DEVELOPMENT REVIEW BOARD  
SUPPLEMENTAL SUBMITTAL

PROJECT NO. PR-2020-004820

**Re:** Hotel Circle Ramada Apartment Conversion DRB Comment Responses (PR-2020-004820)

## LANDSCAPE PLAN

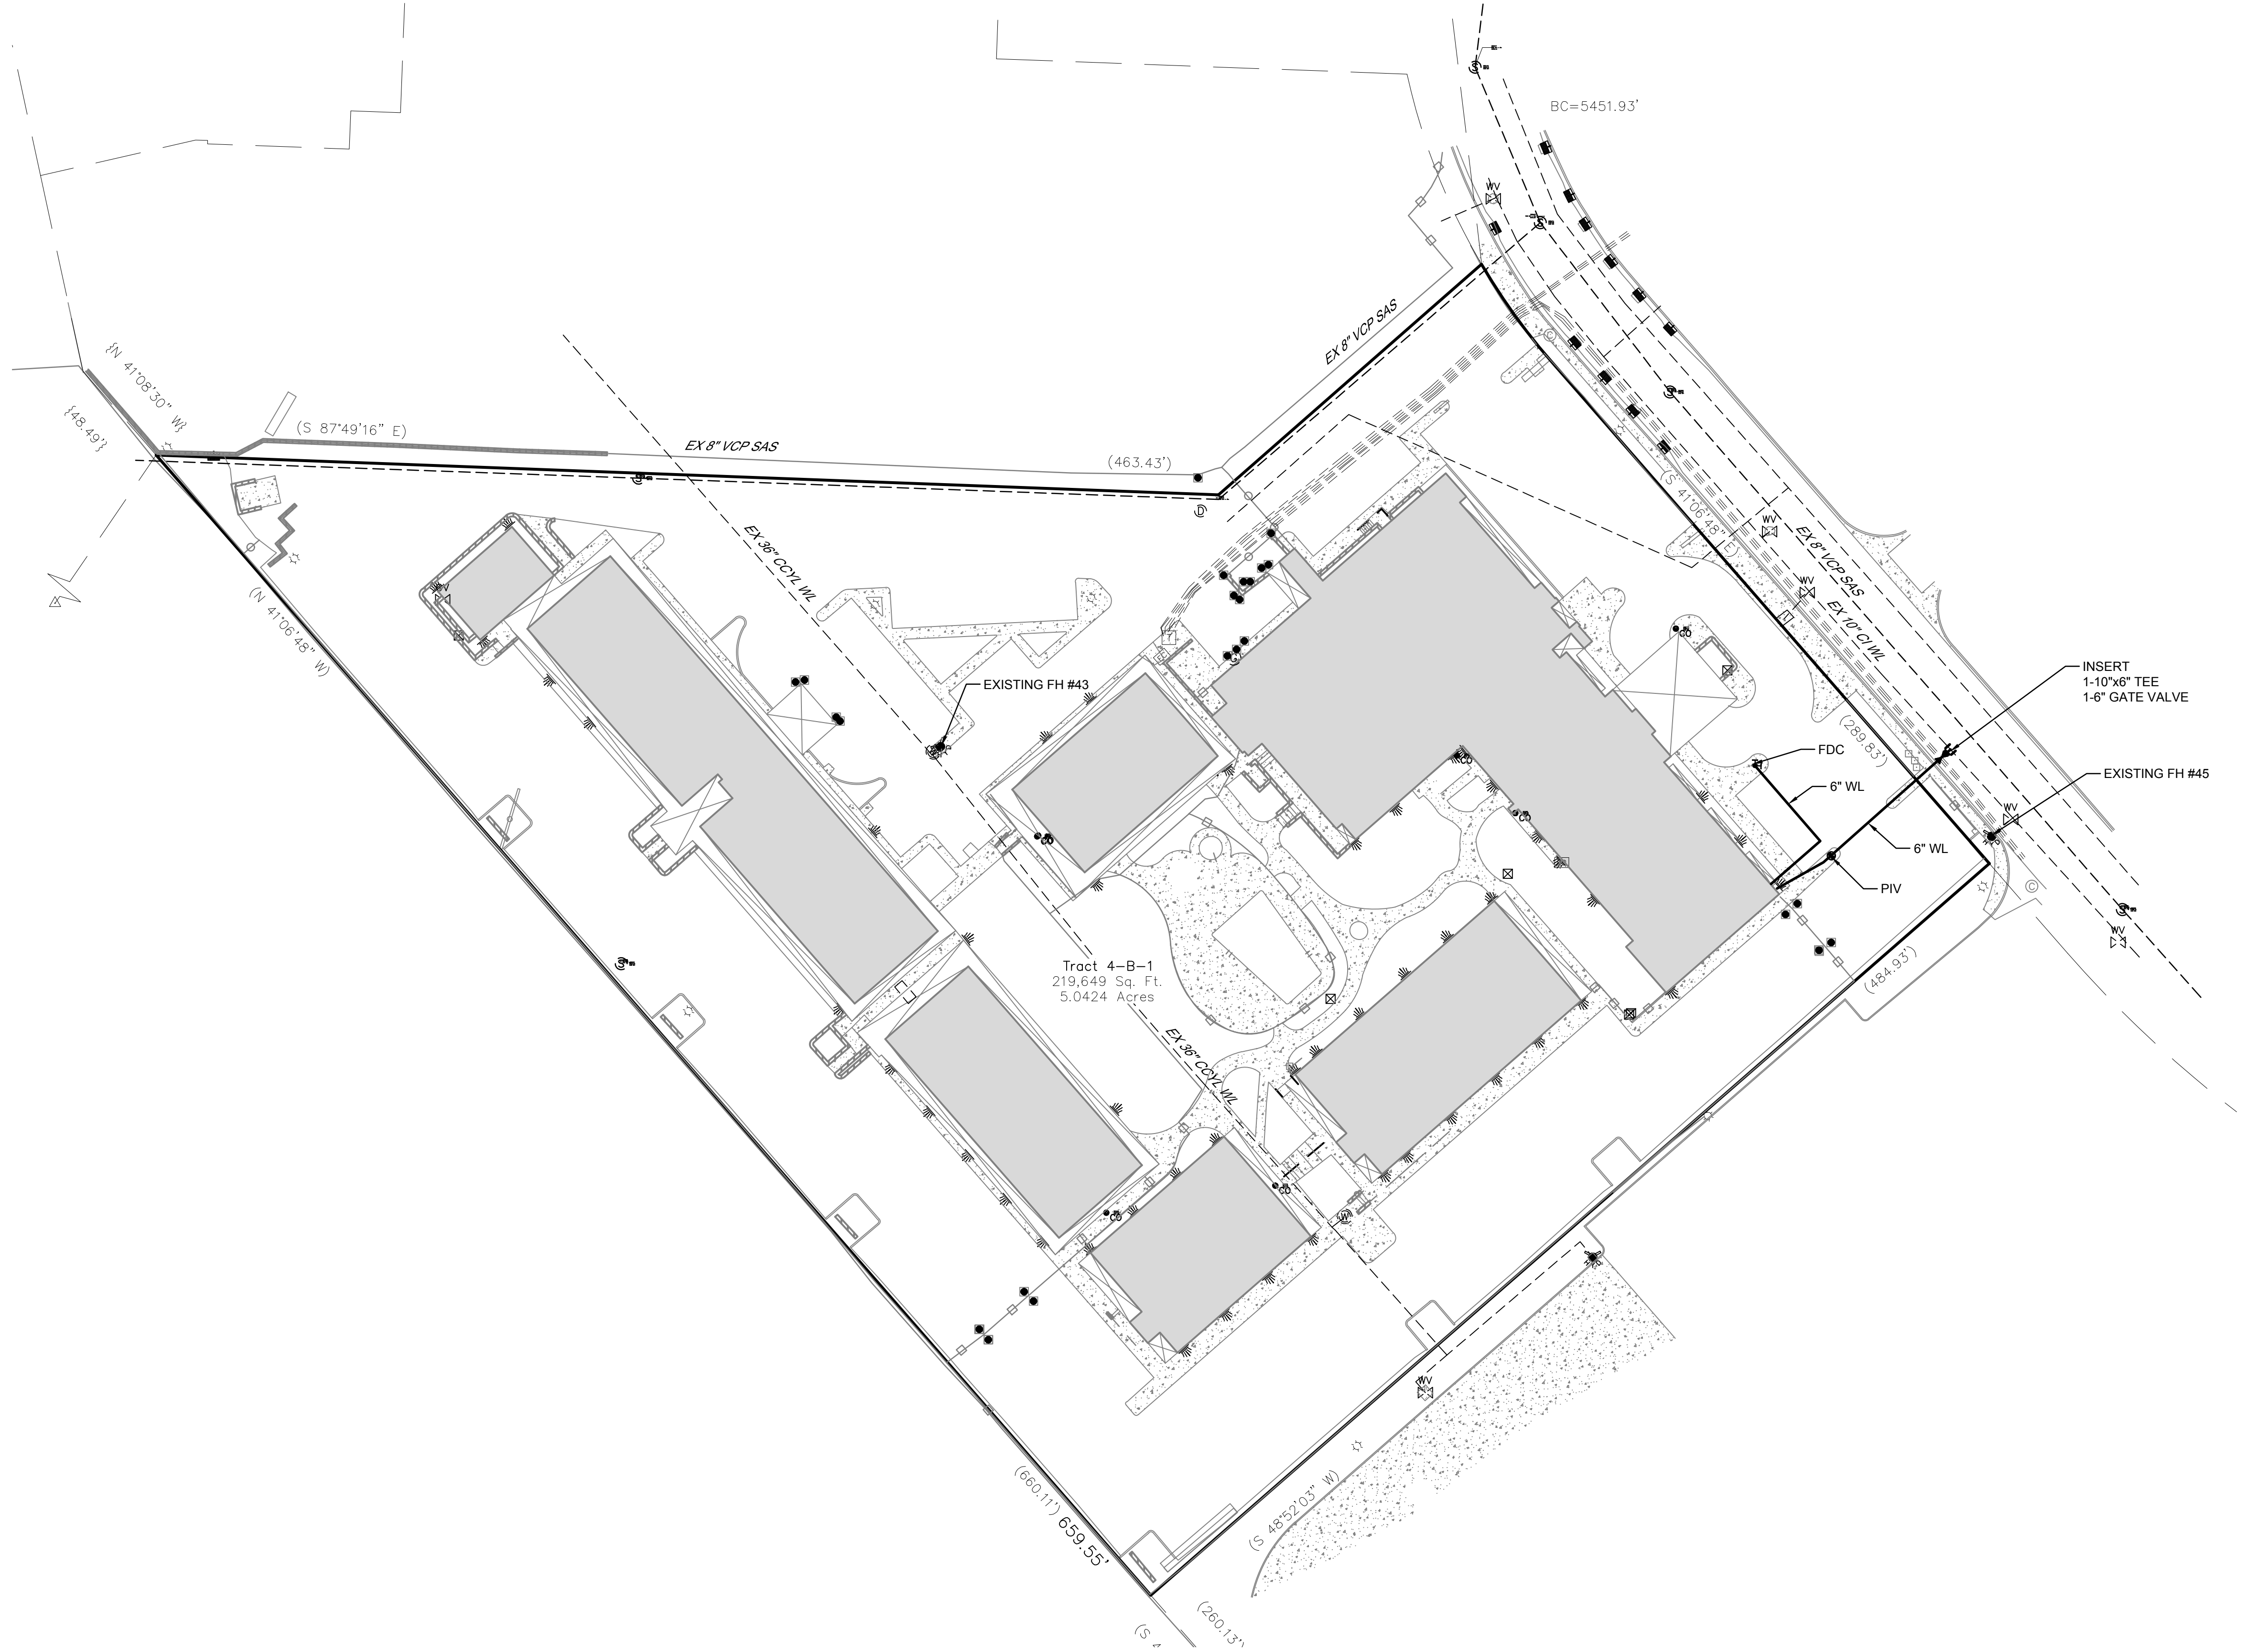
5. See section 5-6(B) for landscape applicability. if the site meets those criteria then additional landscaping in the form of ground level plants will be required- see 5-6(C)(2)(c).

- a. The proposed landscape plan meets the required percentage of ground level plants through a combination of the existing grass turf areas and shrubs.**

EXISTING TREE CALIPER

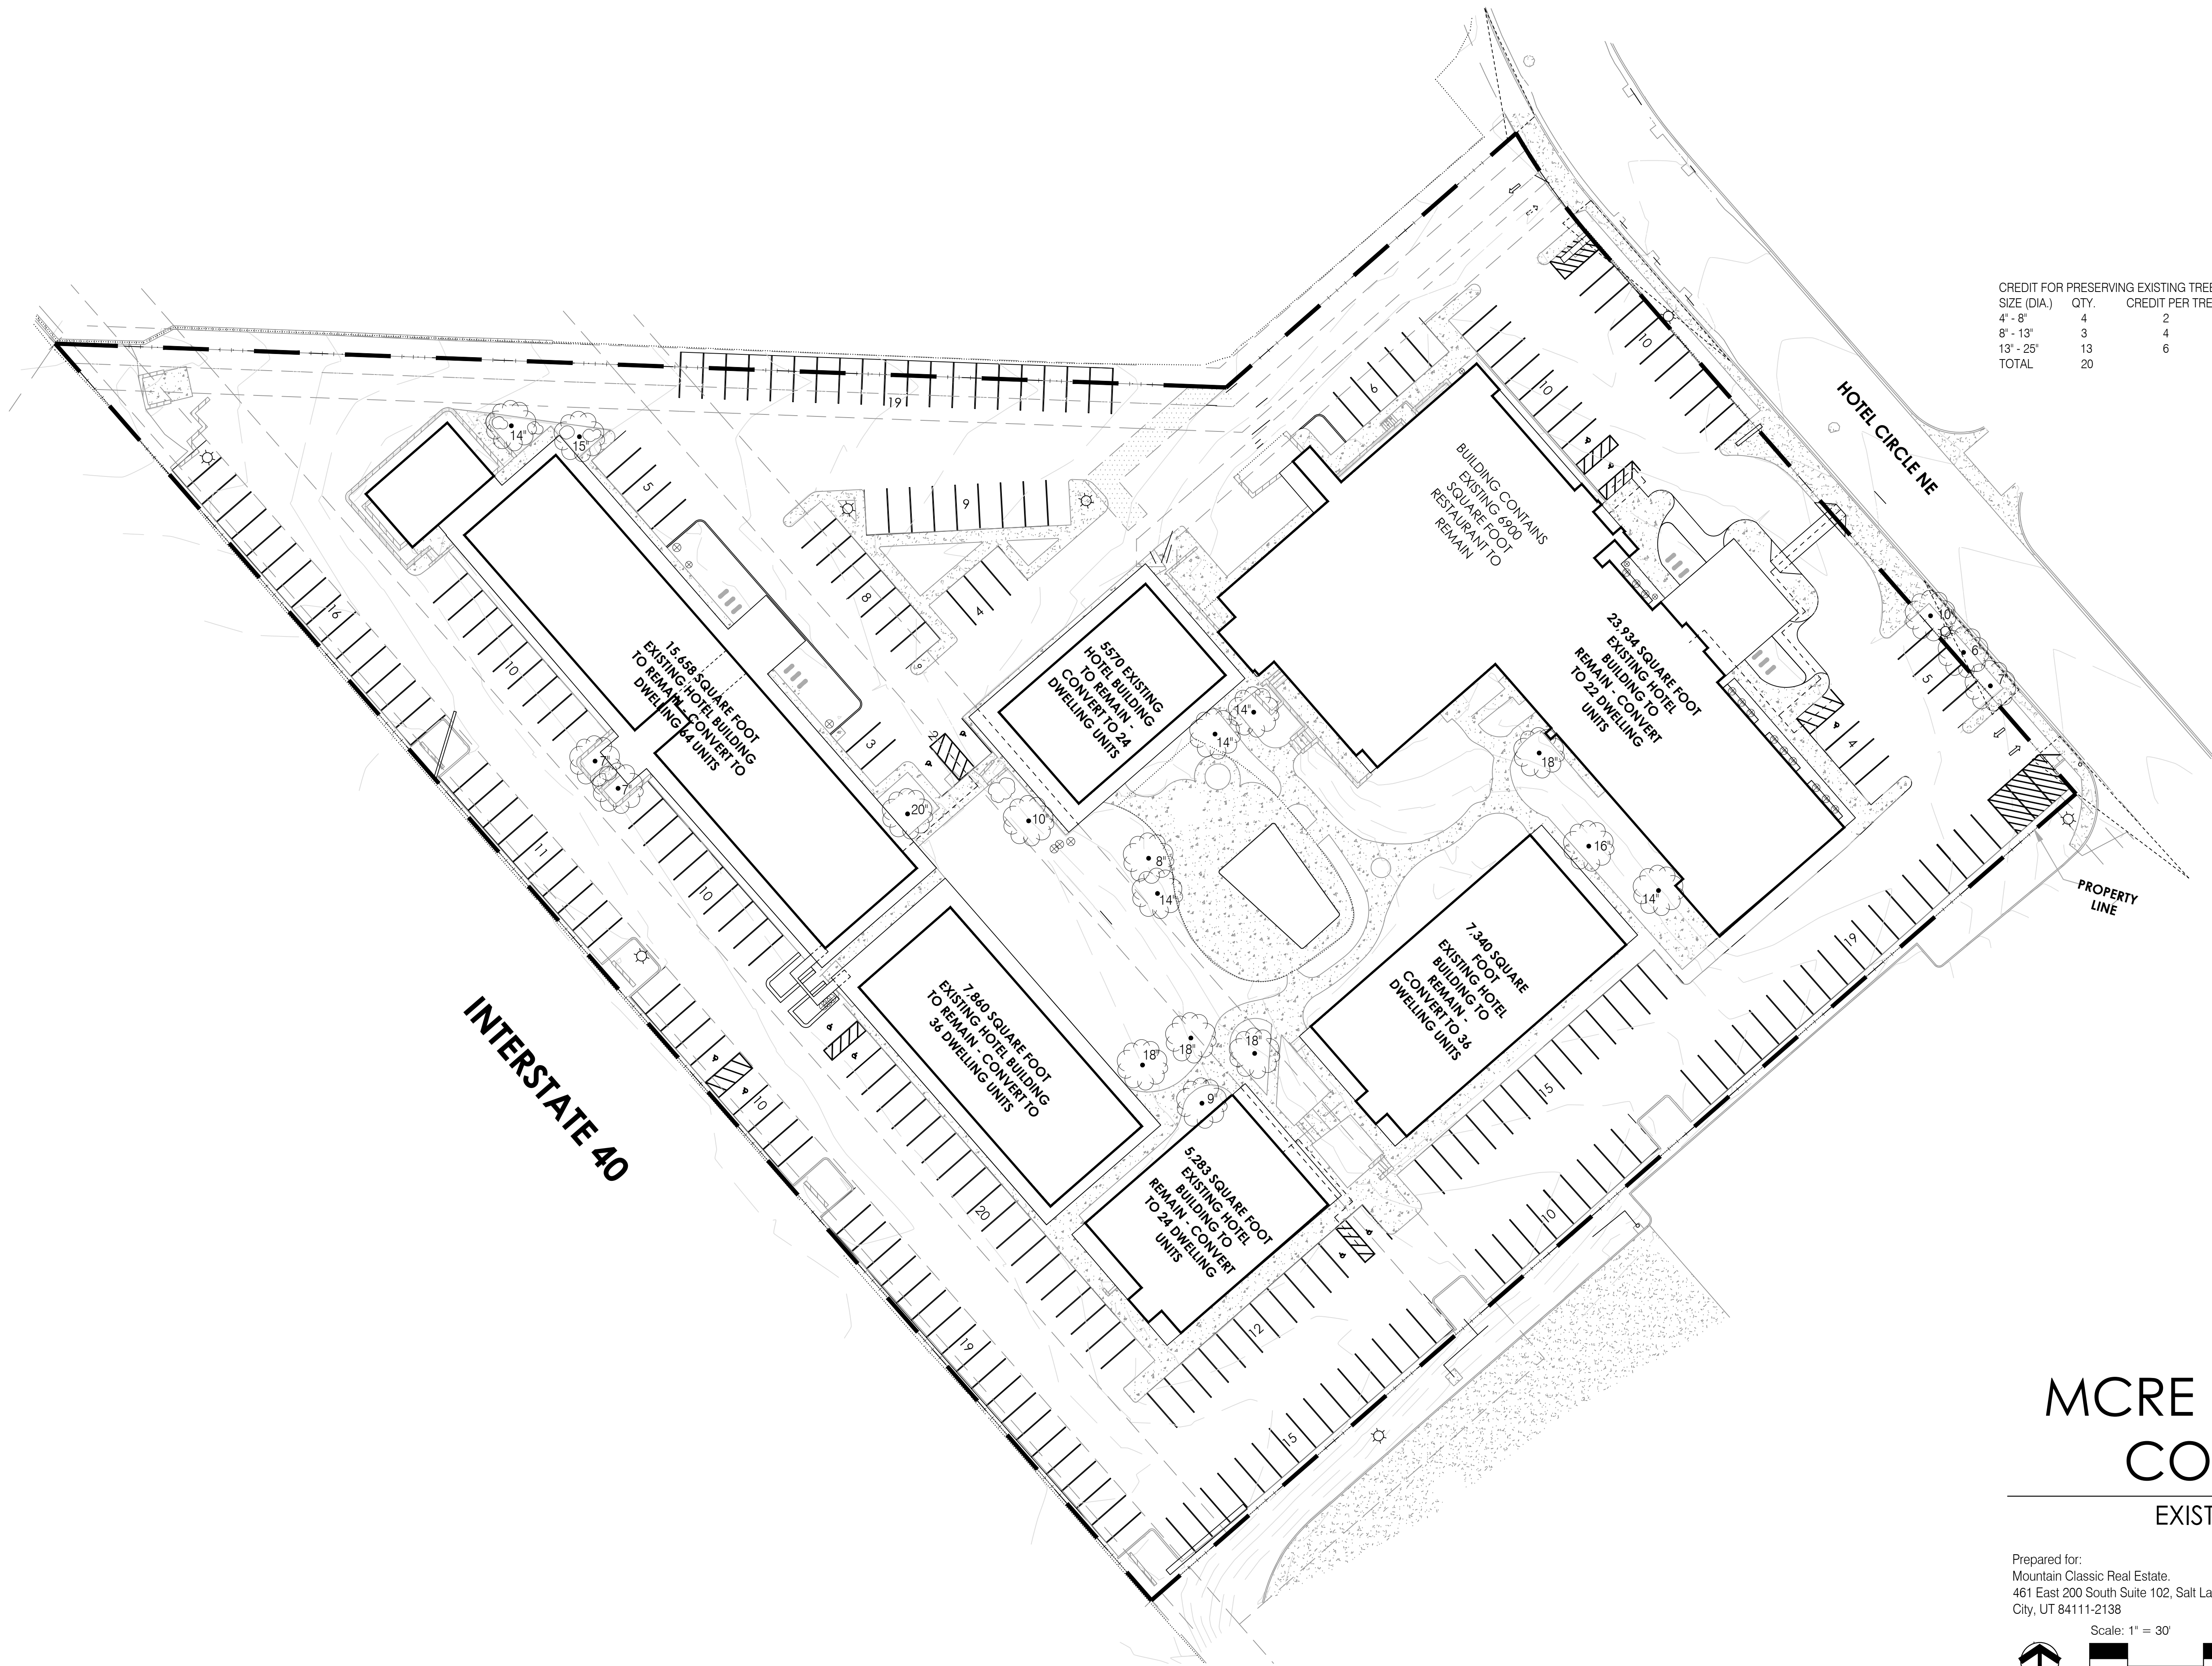
1. Please verify existing tree sizes for tree credit.
  - a. We have created an exhibit that shows the measured caliper of each existing tree and translates that measurement to IDO Table 5-6-2 and the calculations shown on the landscape plan.**
